AGENDA ELLETTSVILLE PLAN COMMISSION Zoom Meeting Thursday, March 4, 2021 - 6:00 P.M.

PC 21-06 – Preliminary Plat Staff Report

PC 21-07- Preliminary/Final Plat Staff Report

PC 21-02 – Preliminary Plat Staff Report

Summary

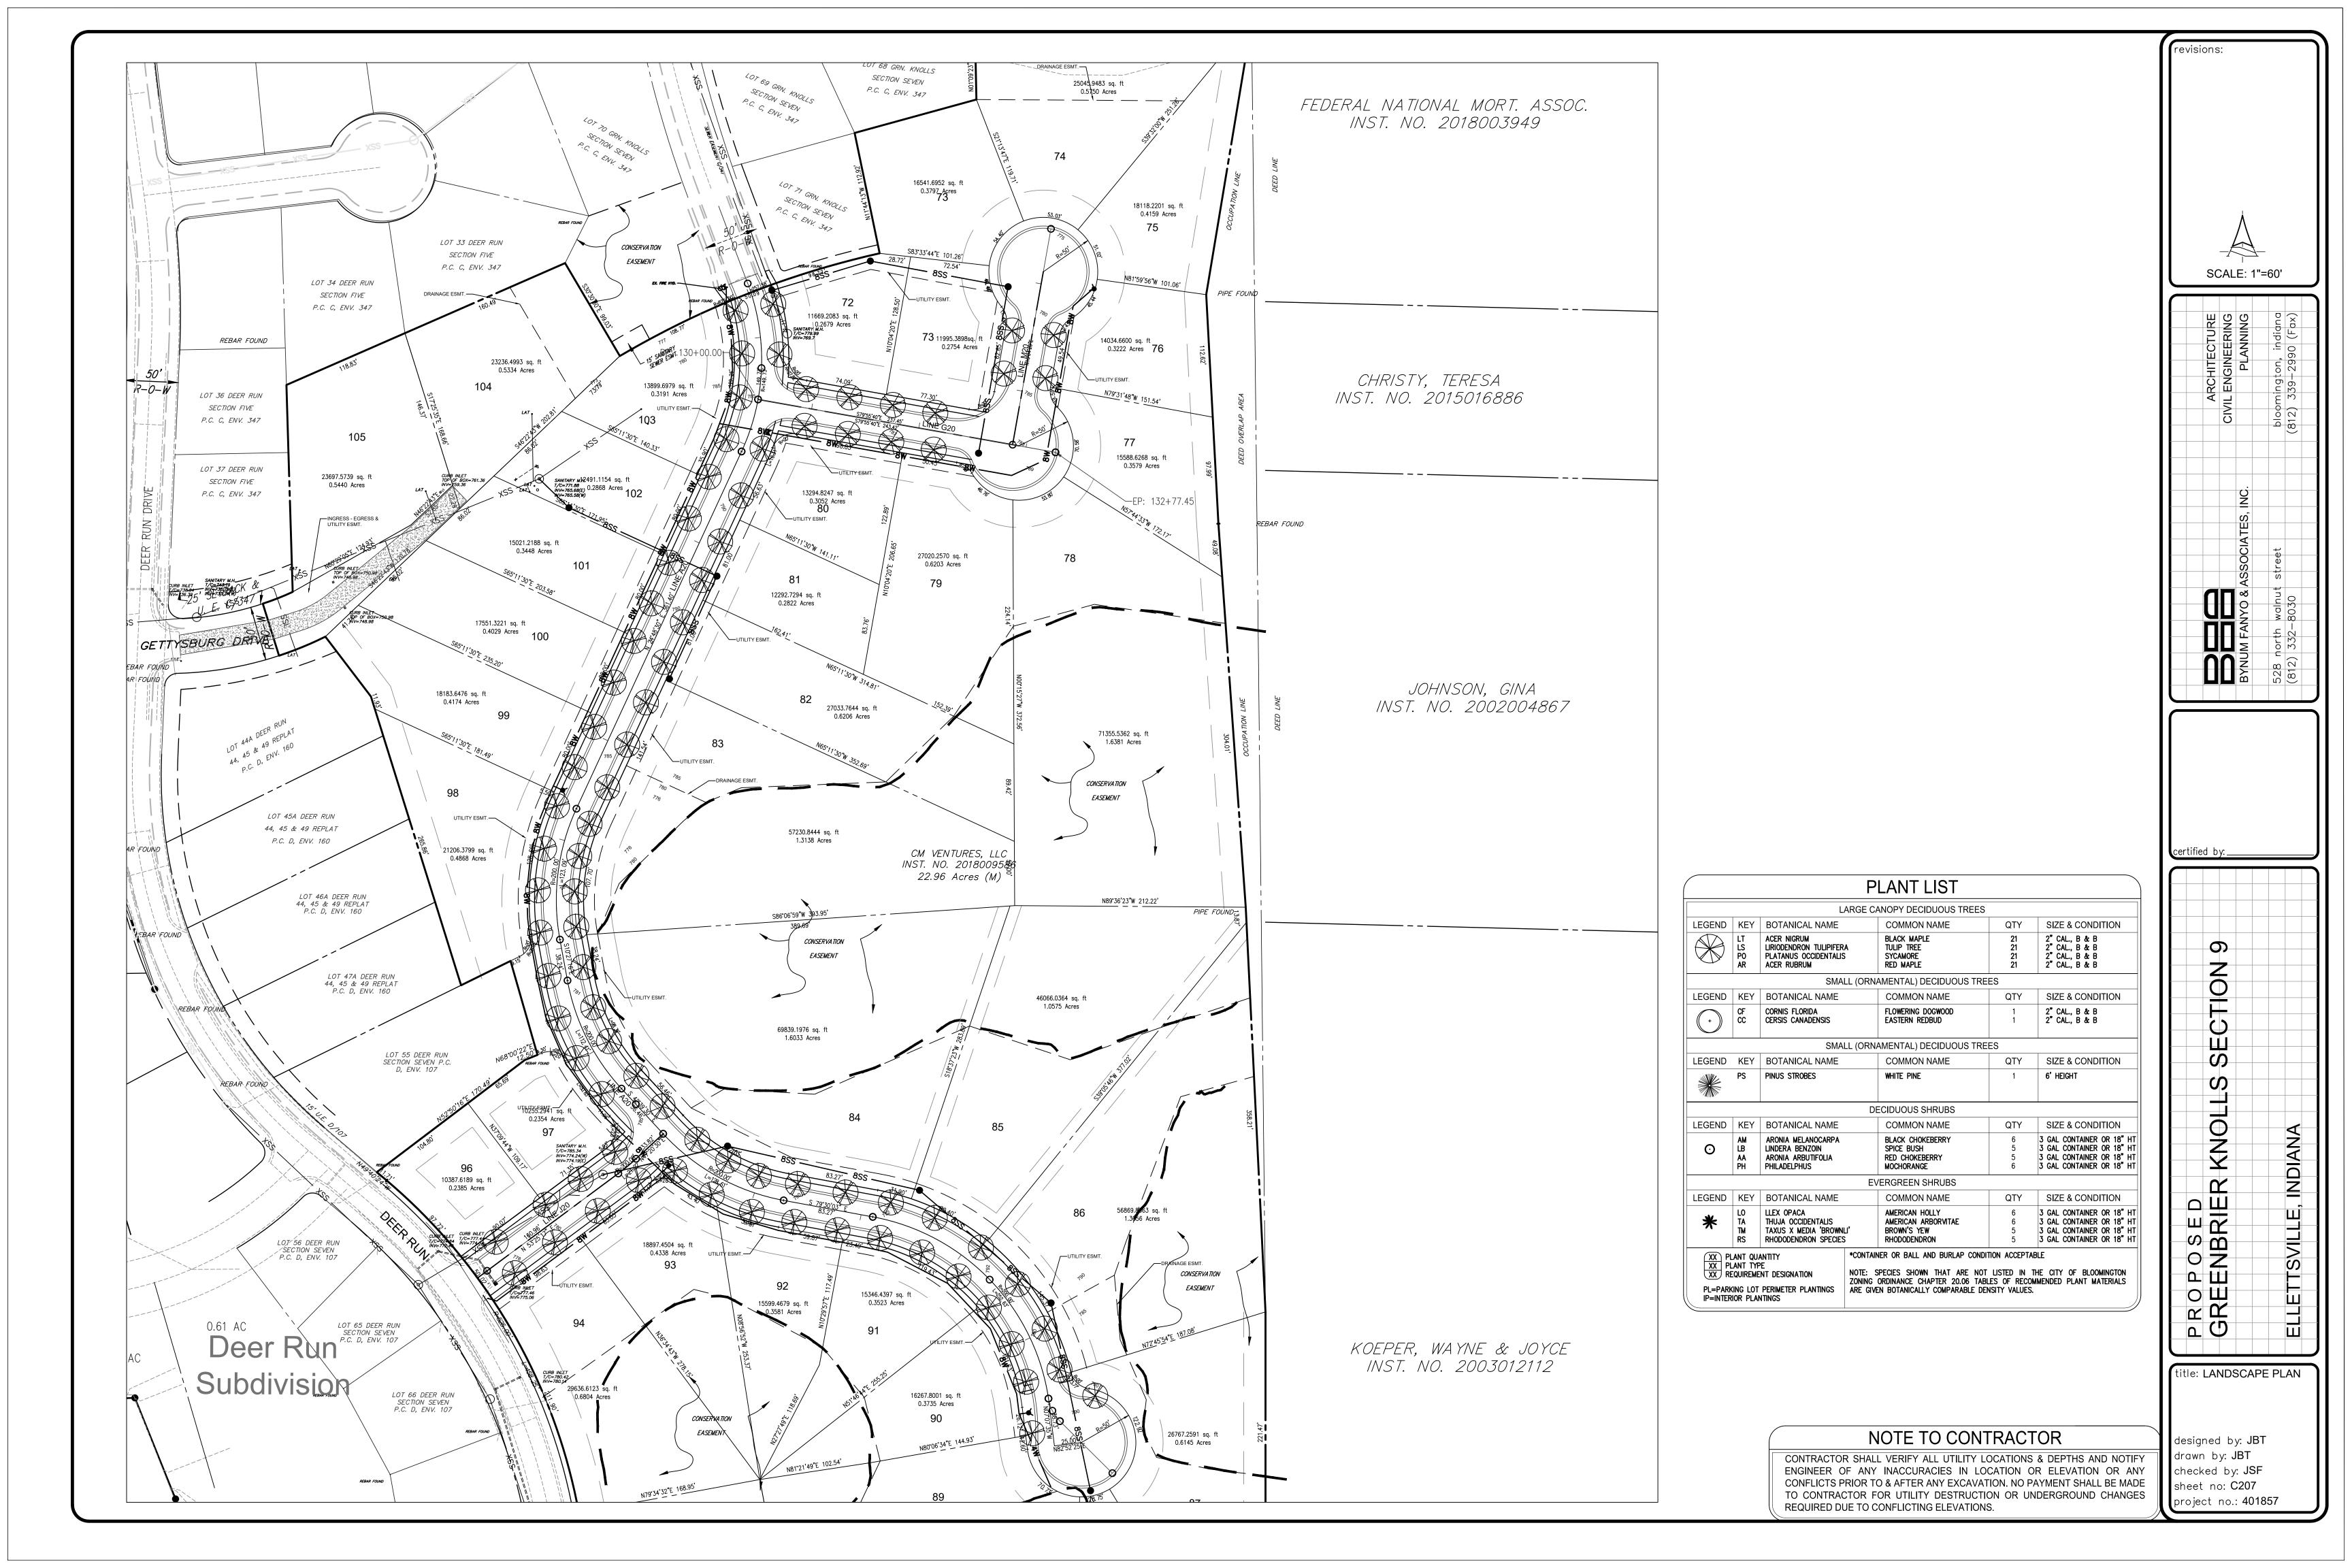
3. Please show any proposed utility/drainage/access easements.

SCALE: 1"=120' title: SITE PLAN

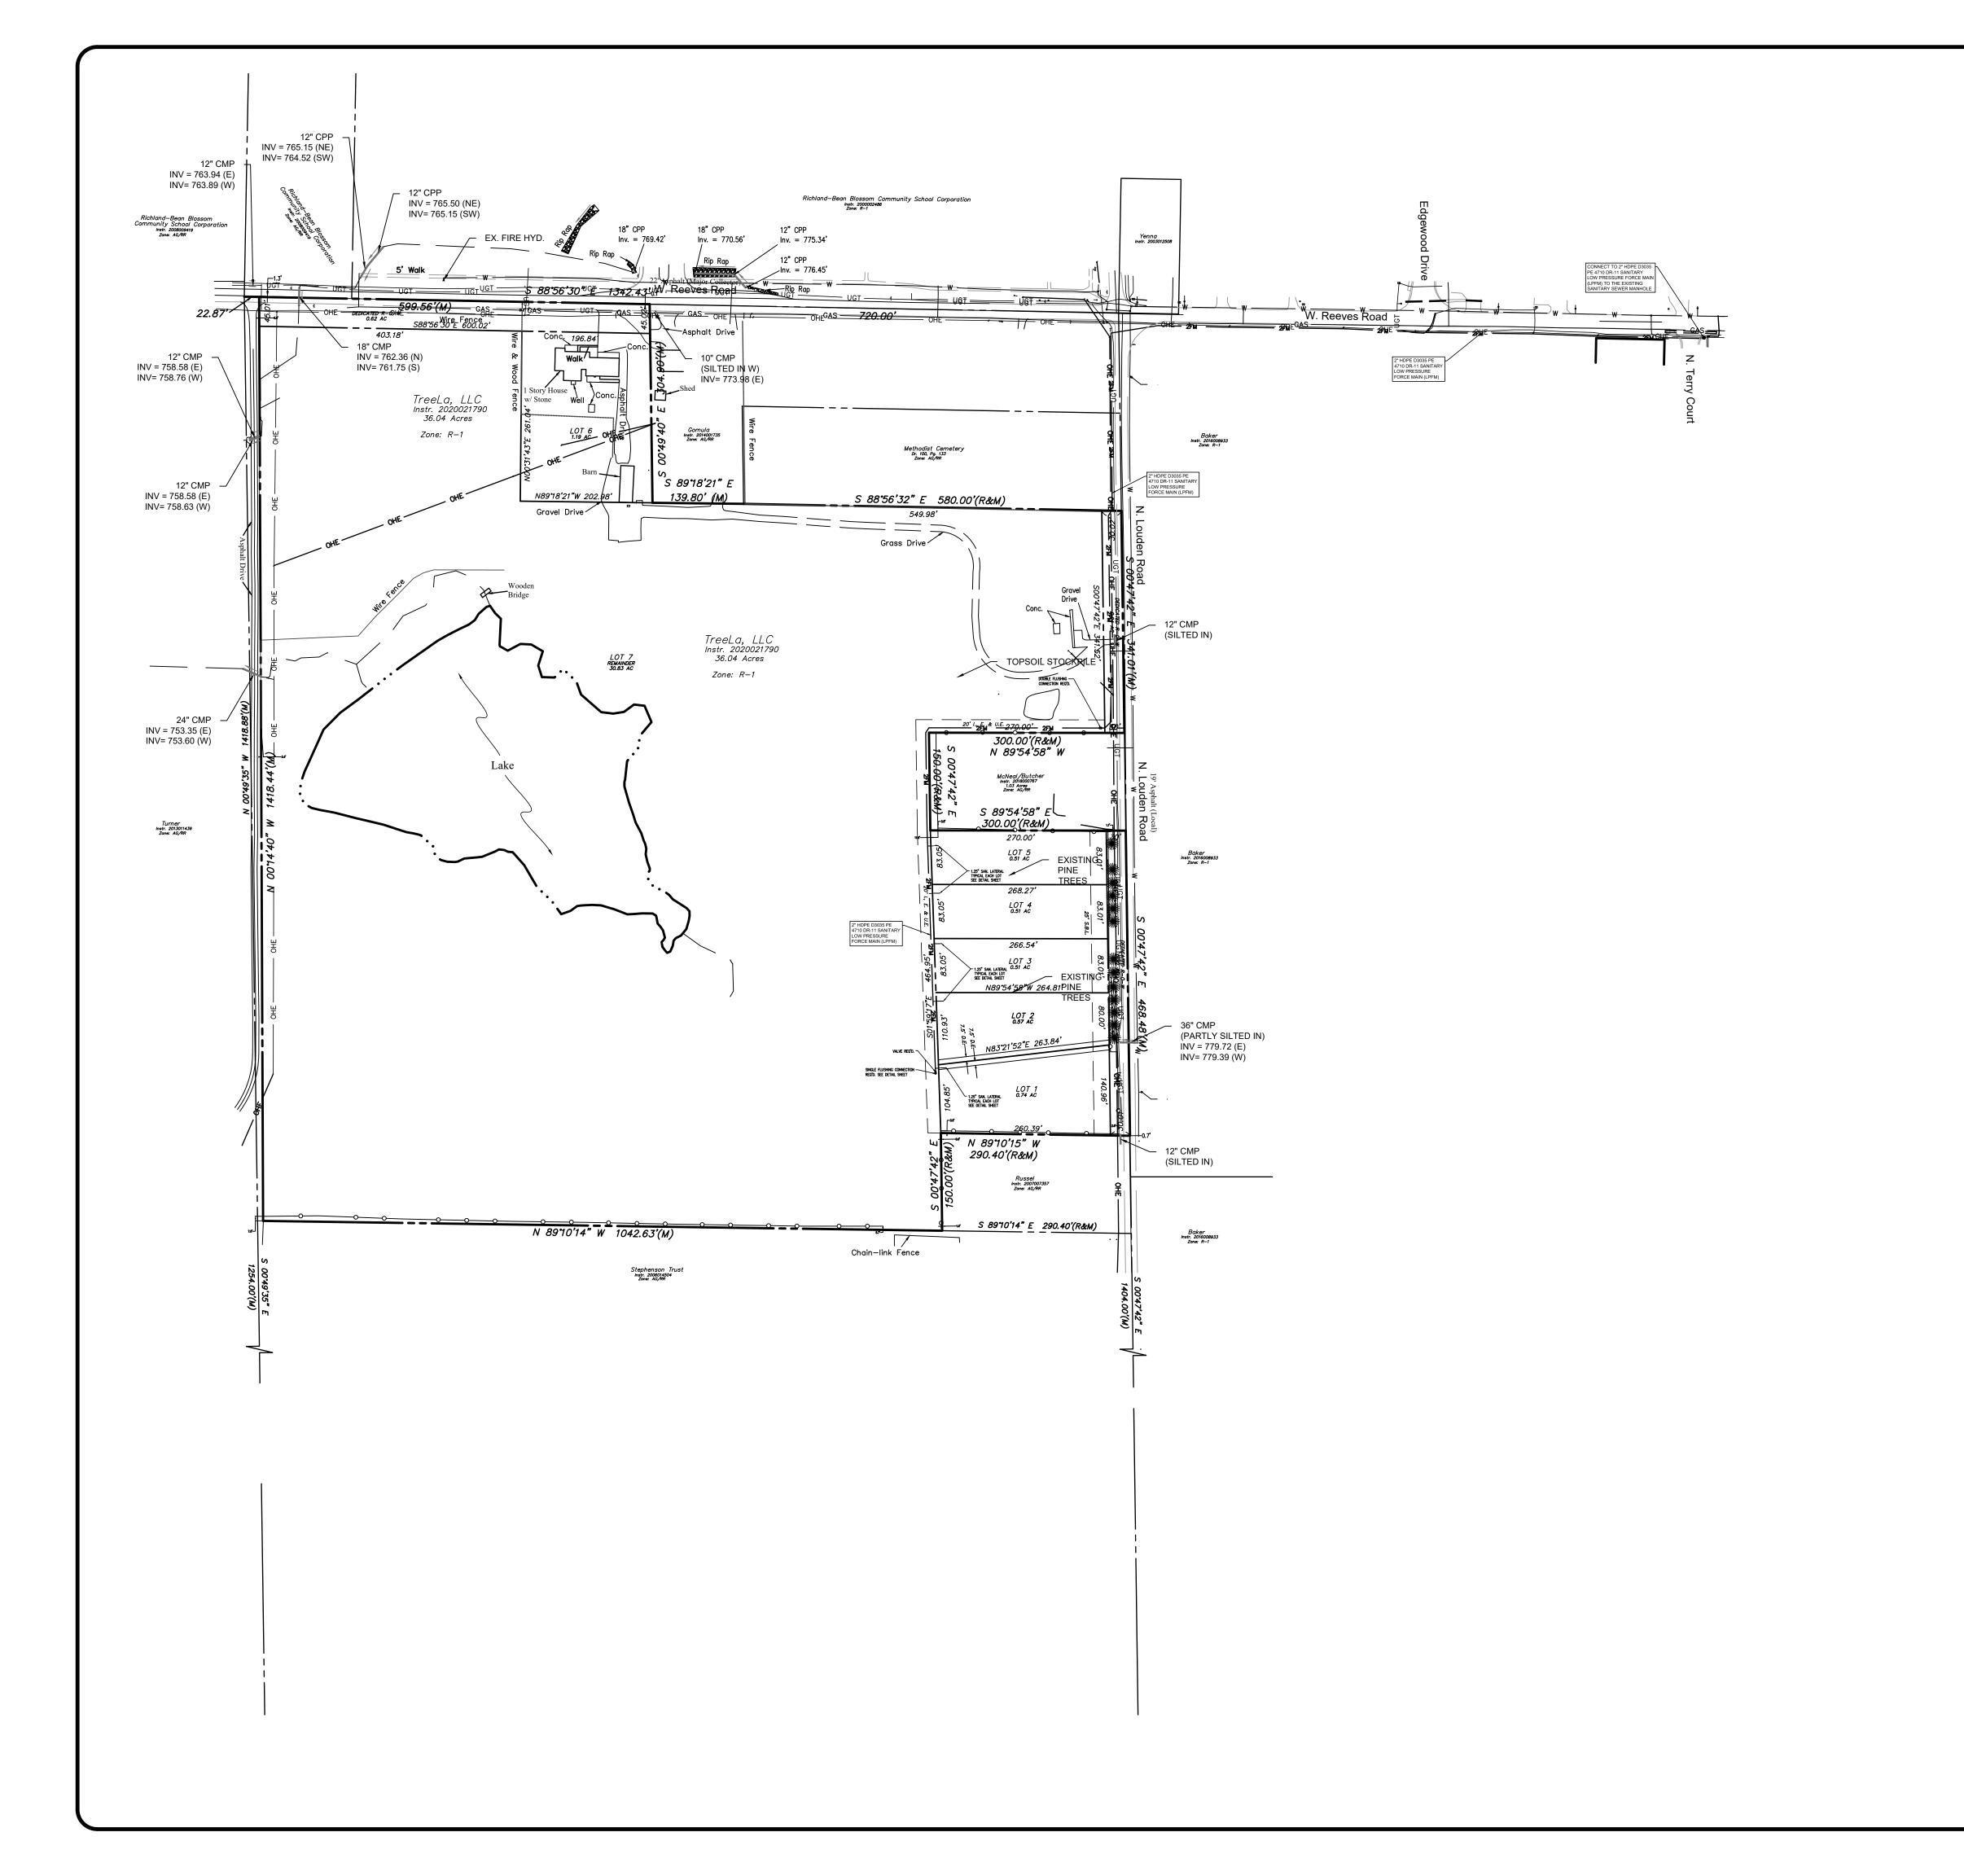
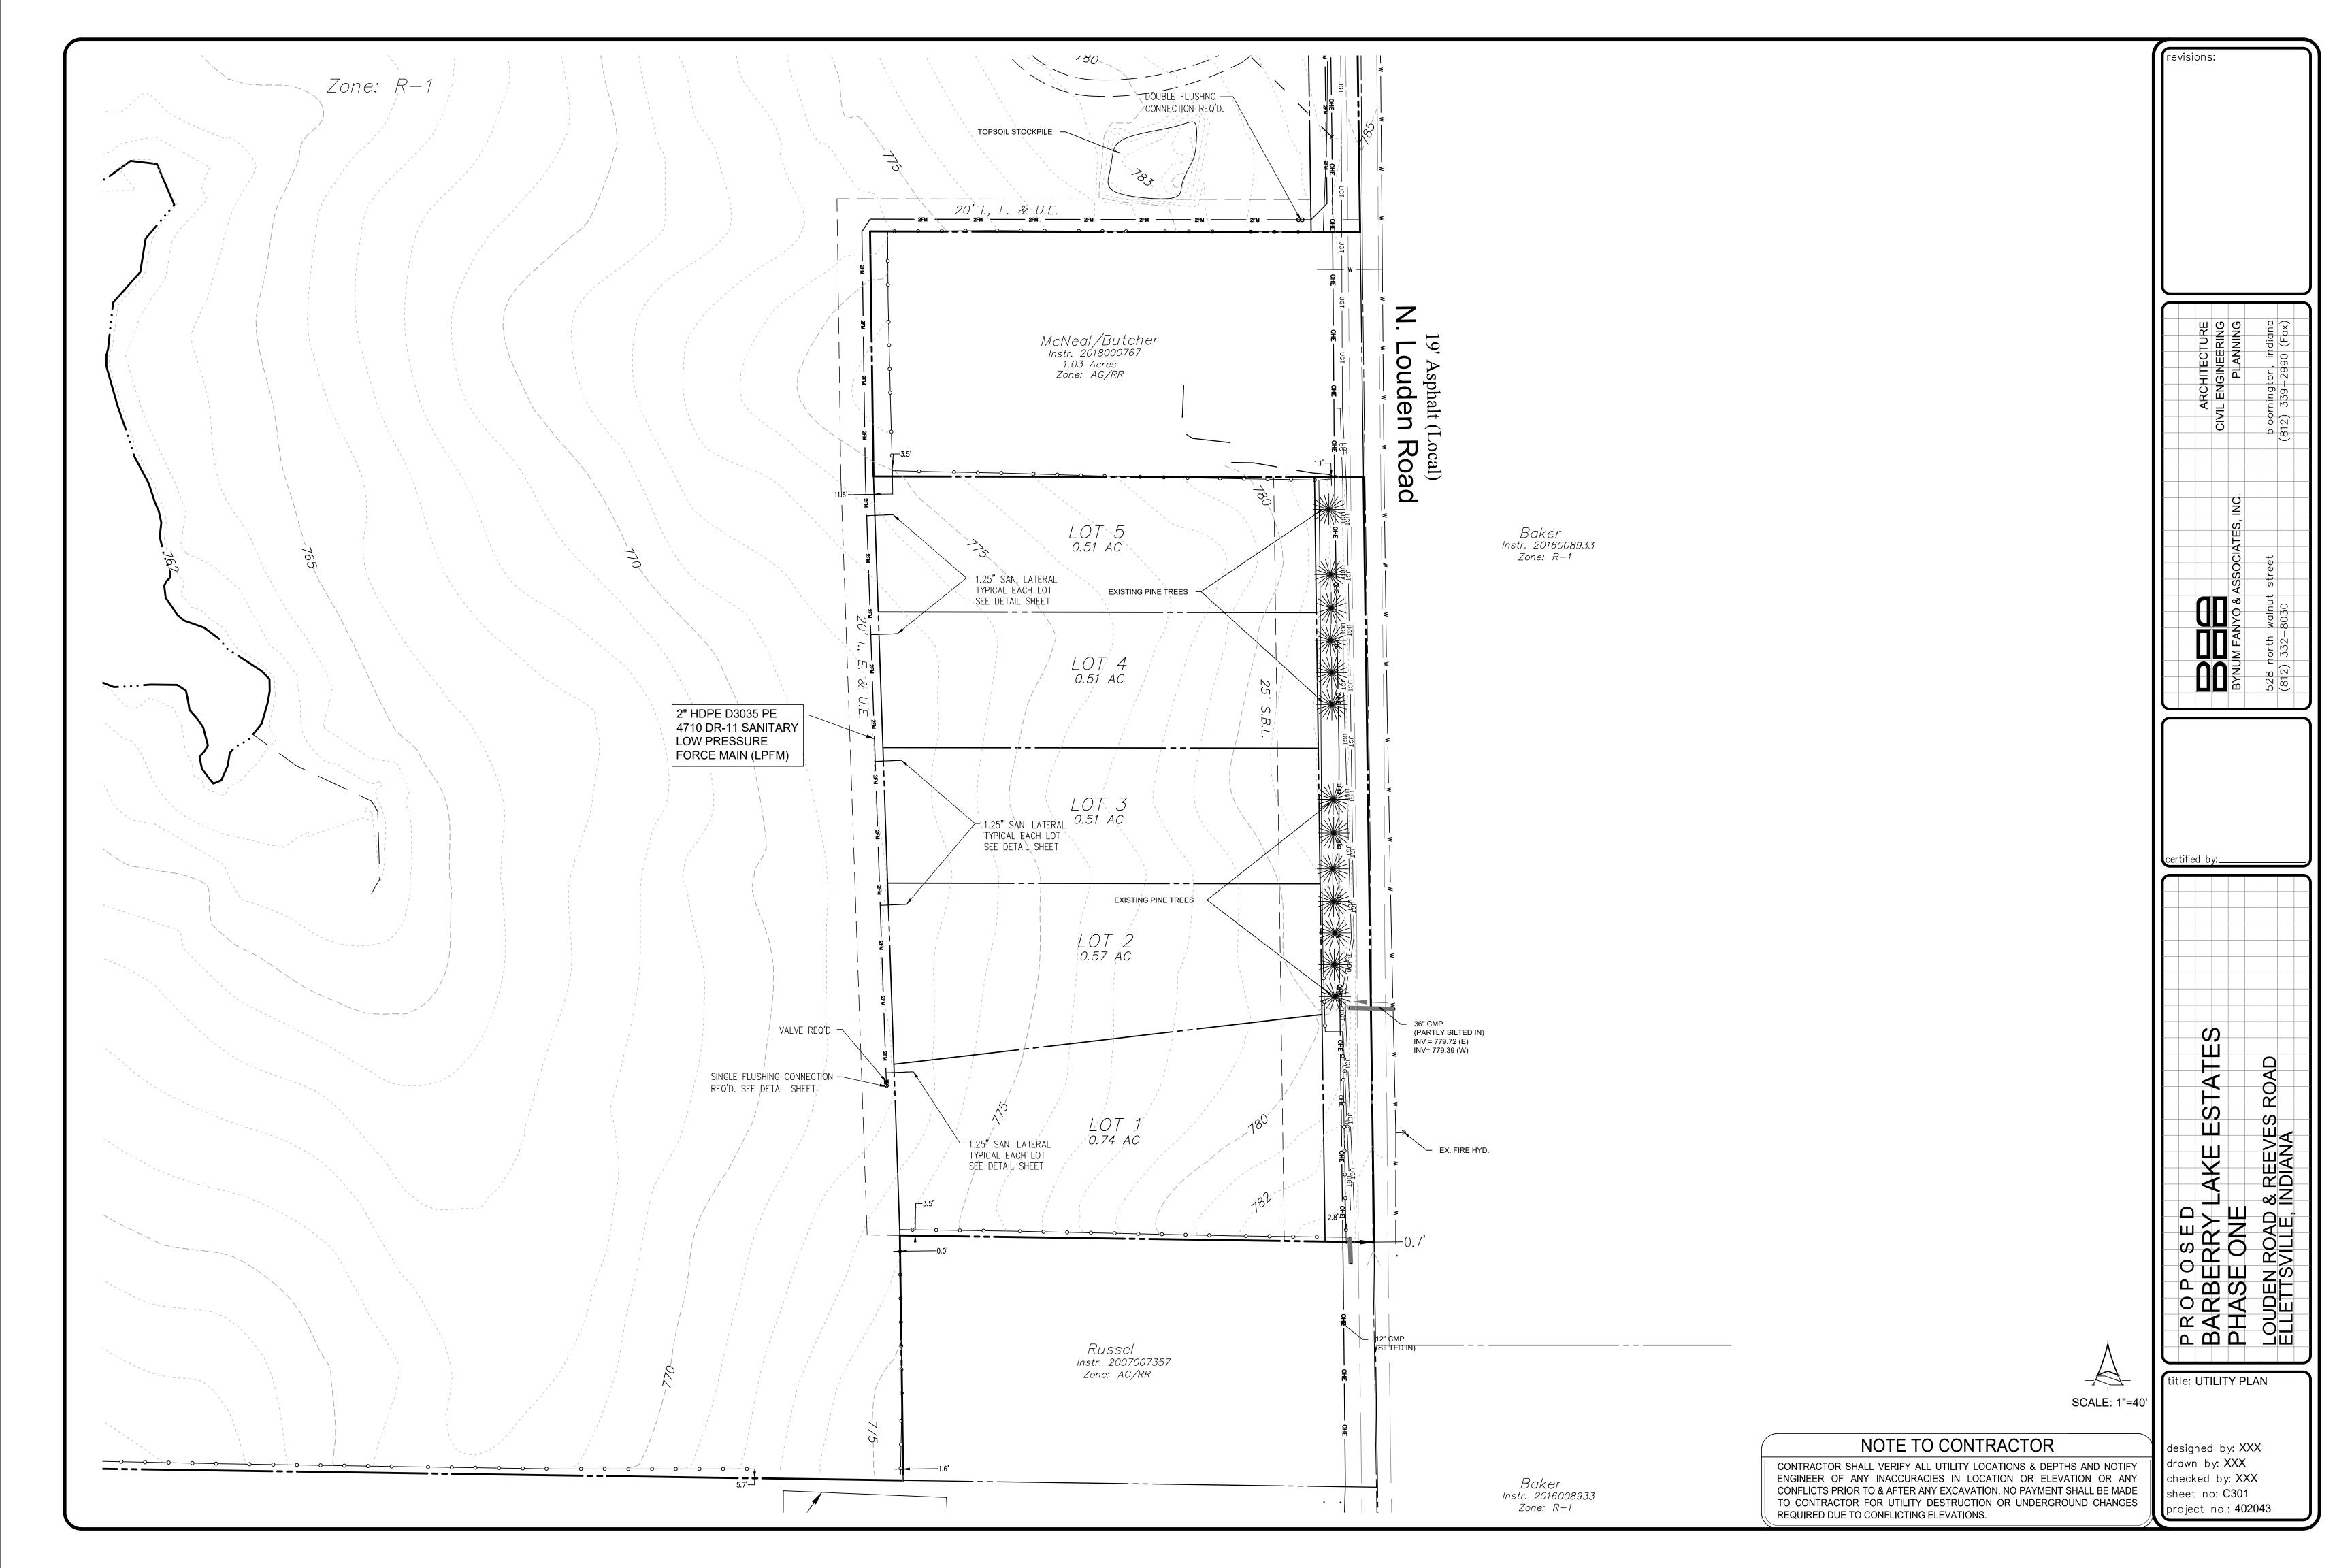
- a. Do future plans call for a street on the west side of these lots?
- 2. Are existing pine trees along Louden Road to be removed or will they stay?
 - a. Can be used to account for a portion of the street tree requirement.
- 3. Under miscellaneous details, several items are marked as City of Bloomington. Please ensure that these details also meet Ellettsville requirements.
